Accessibility Site Visit Report - HC - ANSI

Project Name	Sample Property
Visit Type	3rd
Date of Inspection	02-12-2020
Inspector	Brian White
Site Visit Accompaniment	Jason Pendly
Street Address	123 Main St
City	Greenville
State	South Carolina
Zip Code	29605
Accessibility Codes for this project (Check if used)	2010 ADA, ANSI A117.1, UFAS
Number of Buildings	1
Total Number of Units	80
Number of HC Accessible Units	5
Number of A/V Units	0
Number 1 Bedroom Units (Std/HC)	80/5
General Project Notes:	NOTE – Element Findings at Time of Inspection: This inspection report indicates individual elements as Yes, No, or N/A. Each

Community Kitchen

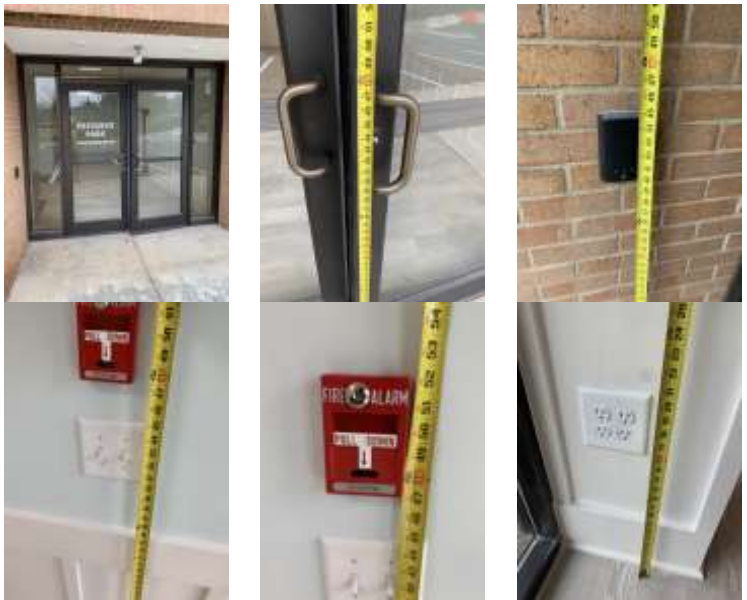
Status of this area	Finished stage
Doorway has a clear opening width 32" min. (ADA 404.2.3)	Yes
Threshold less than 1/2" with bevel or 1/4" no bevel (ADA 404.2.5)	Yes
Interior signs mounted (latch side) have tactile characters (measured from the baseline) between 48" min. - 60" max. (ADA 703.4.1)	Yes
Interior sign characters at least 5/8" but no more than 2" tall (ADA 703.5.5)	Yes
Electric switches/outlets 44" max. AFF over workspace others behind counter 46" max. AFF (ADA 308.2.2 (b))	Yes
Kitchen counters 34" max. AFF (ADA 804.3.2)	Yes
Top lip of kitchen sink 34" max. AFF (ADA 606.3)	Yes
Kitchen sink has 27" knee clearance, 30" clear width, and 9" min. height toe clearance (ADA 306)	Yes
Are drain and water supply pipes insulated or covered by skirt (ADA 606.5)	Yes
Faucet controls Lever Handle style or easy to operate (ADA 309.4)	Yes
Pass through kitchen has 40" min. clear width (ADA 804.2.1)	Yes
At least 50% of shelf space within 48" max - 15" min AFF (ADA 804.5)	No

Restroom Photos

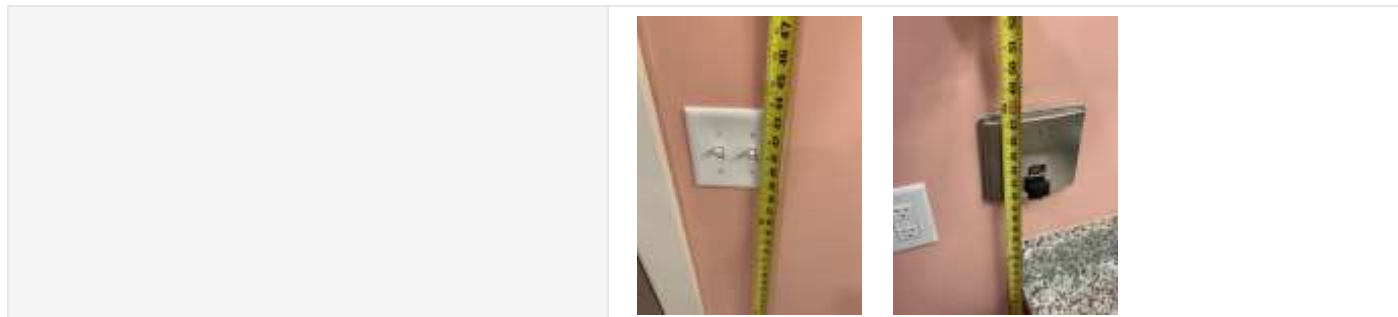
12" min. clearance on the push side of the door (with door closure) (ADA 404.2.1)	Yes
Interior signs mounted (latch side) have tactile characters (measured from the baseline) between 48" min. - 60" max. (ADA 703.4.1)	Yes
Interior sign characters at least 5/8" but no more than 2" tall (ADA 703.2.5)	Yes
Does the door take at least 5 seconds to close (2010 ADA 404.2.8.1)	Yes
Electric switches 46" max. (obstructed) 48" max. AFF (unobstructed) (ADA 308)	Yes
Coat hooks and shelves 40" min AFF 48" max. AFF (ADA 603.4)	Yes
Urinal provided in restroom	Yes
Toilet paper dispenser 19" min. - 48" max. AFF and 7" - 9" from front lip of toilet (ADA 604.7)	Yes
Soap dispenser, paper towel, coat hook, etc. 48" max. with 30" x 48" clear floor space (ADA 308)	Yes
Mirror mounted with bottom edge of the reflecting surface 40" max. AFF (ADA 603.3)	Yes
In all other toilet rooms, is there an unobstructed turning space (60" diameter circle or T-shape) (ADA 603.2.1, 304.3.1)	Yes

HC Unit Kitchen Photos

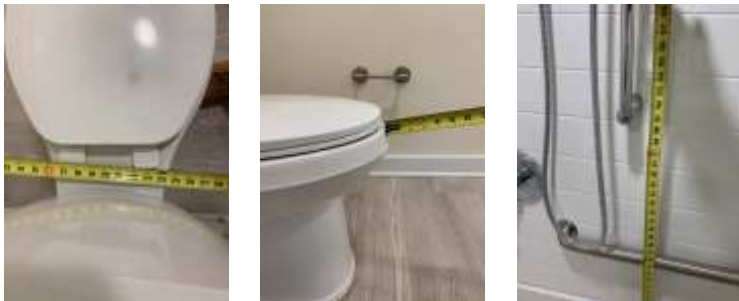
Status of this area	Finished stage
Doorway has a clear opening width 32" min. (ANSI 404.2.2)	Yes
Door hardware does not require tight grasping or twisting to operate (ANSI 404.2.6))	Yes
Threshold less than 1/2" with bevel or 1/4" no bevel (ANSI 303.3))	Yes
18" min. clearance on the pull side of the door (ANSI Table 404.2.3.2)	Yes
Electric switches 48" max AFF (unobstructed) or 46" max AFF (obstructed). (ANSI 308.3.2))	Yes
Toilet (Elements indicated are NOT compliant) (ANSI 603 & 604)	Toilet centerline exactly 18" from the closest side wall. ANSI 604.2 calls for 16" min – 18" max from nearest side wall.
Toilet paper dispenser 19" min. AFF and 7" - 9" from front lip of toilet (ANSI 604)	No
